STRUCTURAL BLUEPRINT

G+1 Farm Storage + Residence

Mithanpur Urf Naimtulla Nagar, Moradabad, Uttar Pradesh

SHEET 9: INDEPENDENT STRUCTURAL REVIEW & RECOMMENDATIONS

SHEET 3: BEAM LAYOUT PLAN

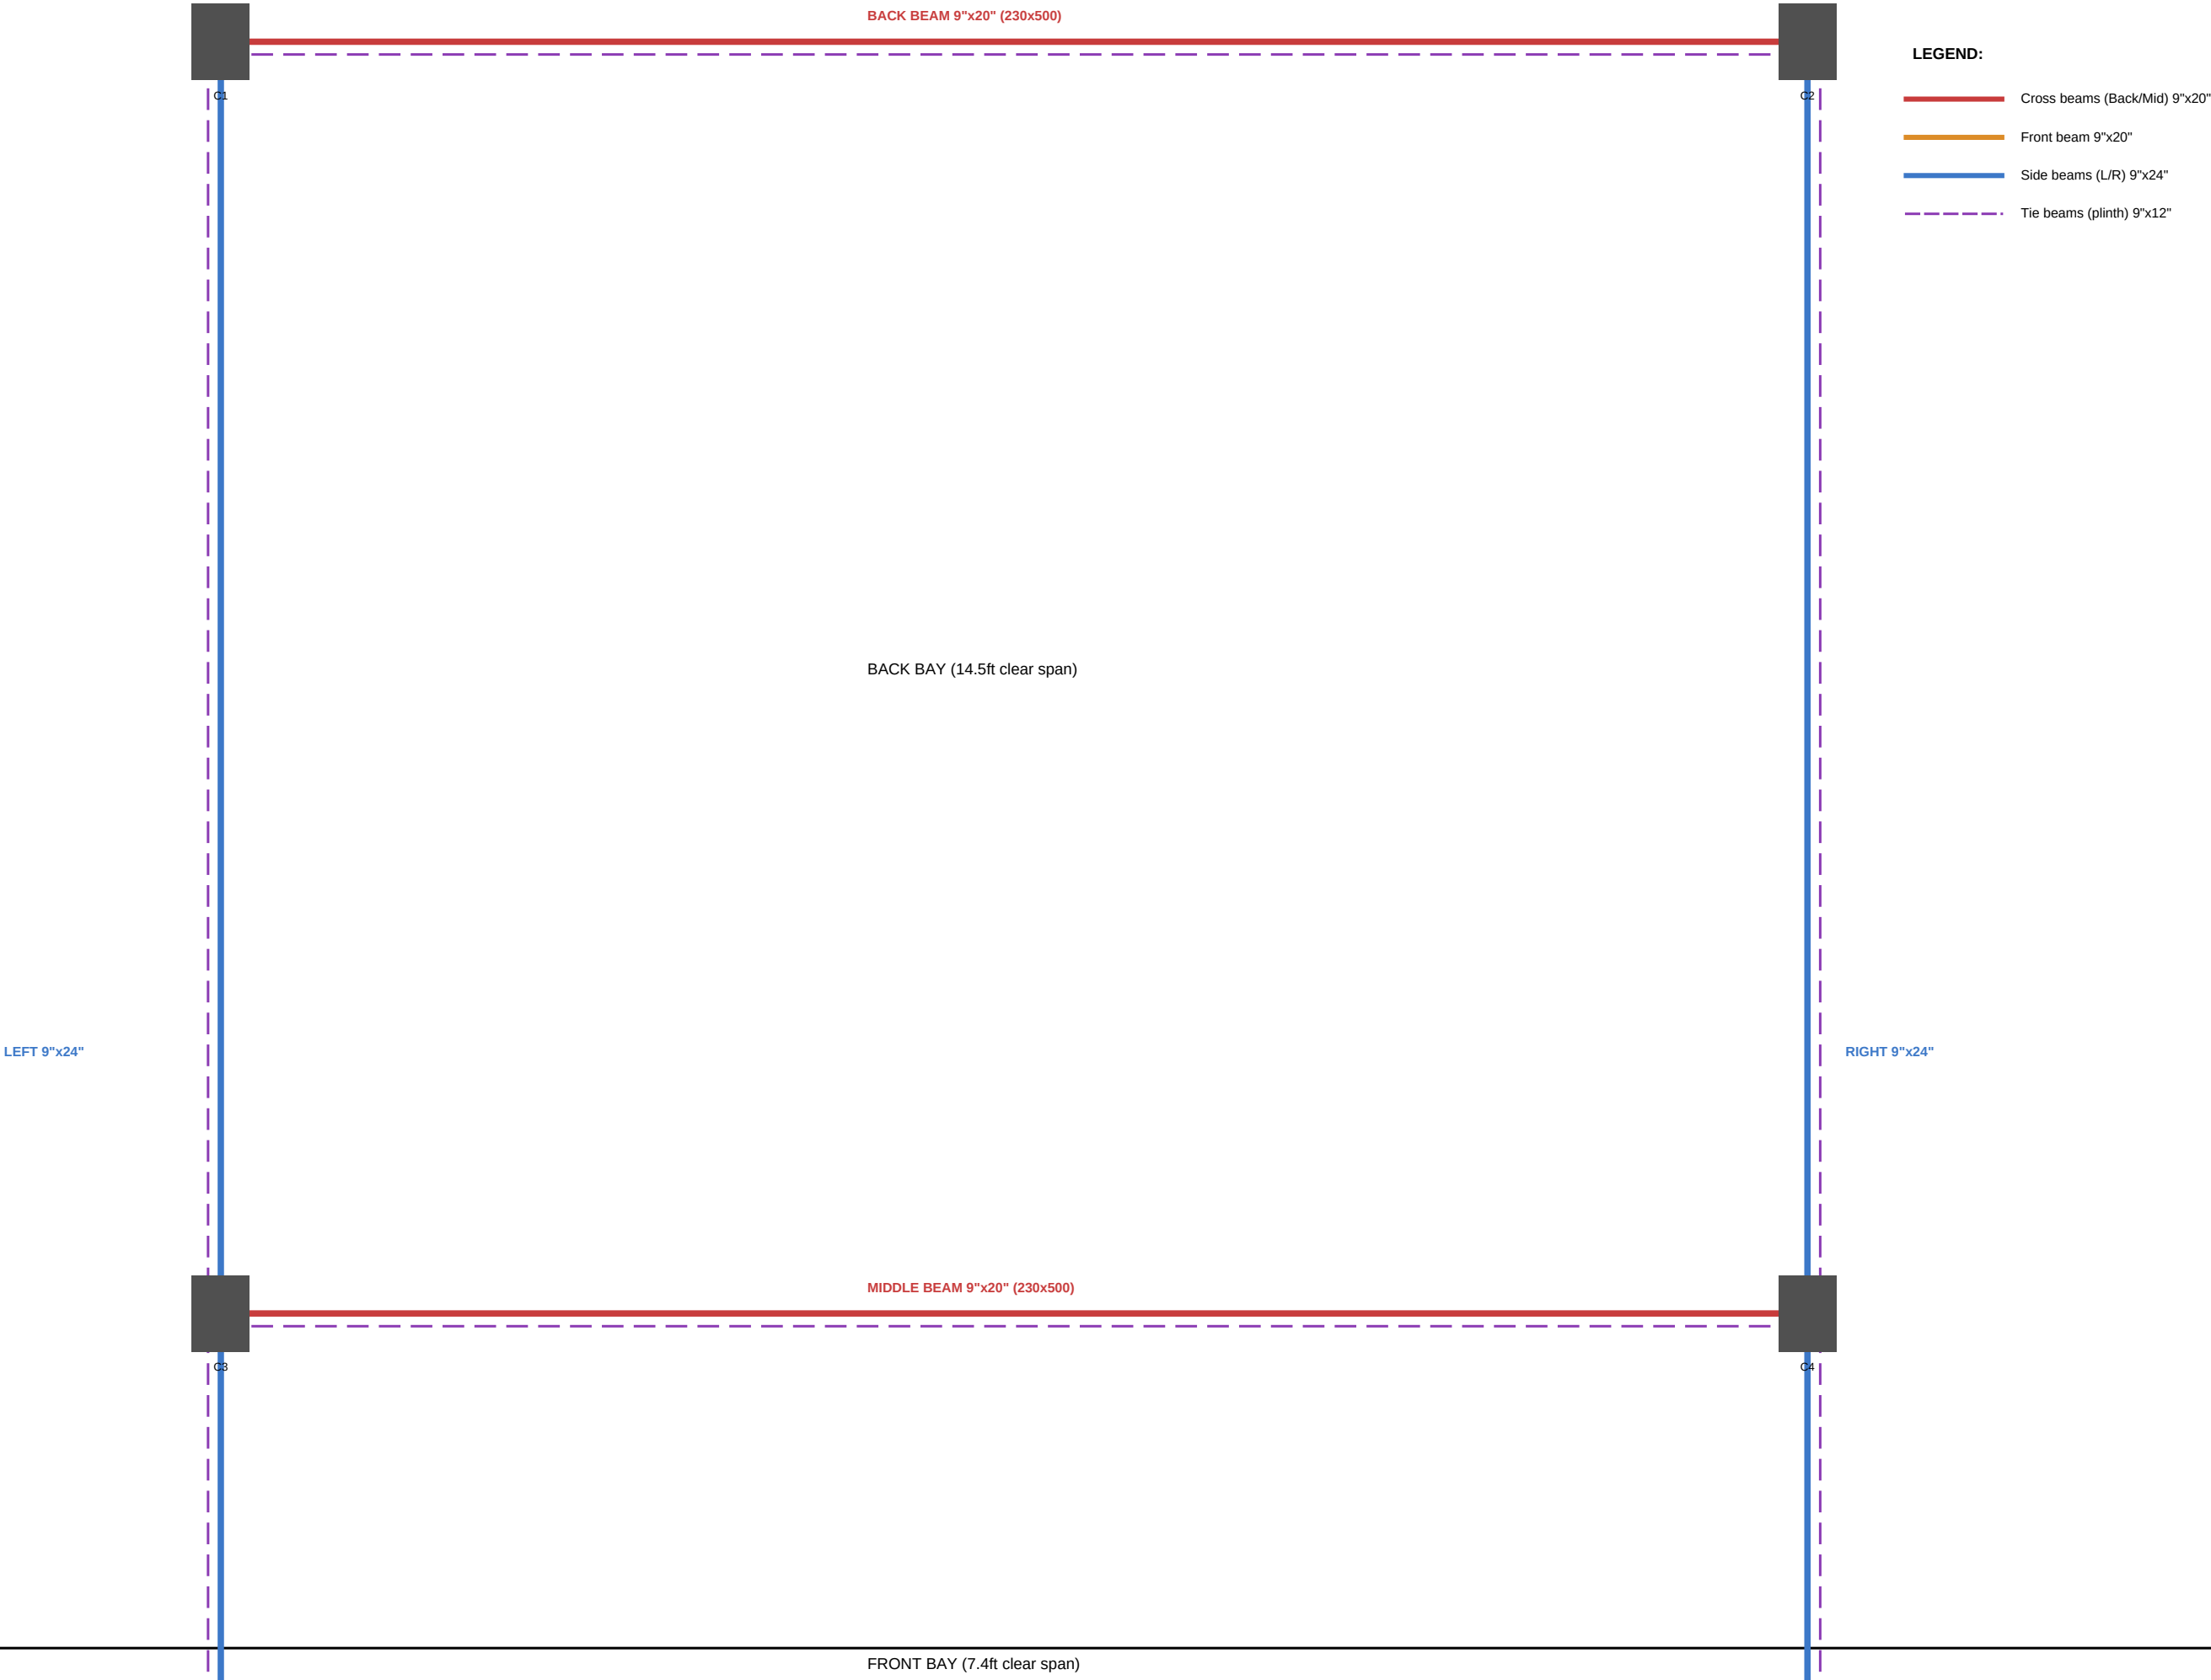
3. BACK BAY SLAB: Increase from 150mm to 175mm (7") for the back bay panel only (between middle beam and back beam). Resolves deflection concern (L/d improves to 28).
Cost: ~Rs 12,000 additional concrete + steel. Strongly recommended.

5. SIDE BEAM MID-SPAN: If any deflection visible during construction, add MS angle bracket (100x100x10mm) as a knee brace from C3/C4 column face to beam soffit at mid-span.
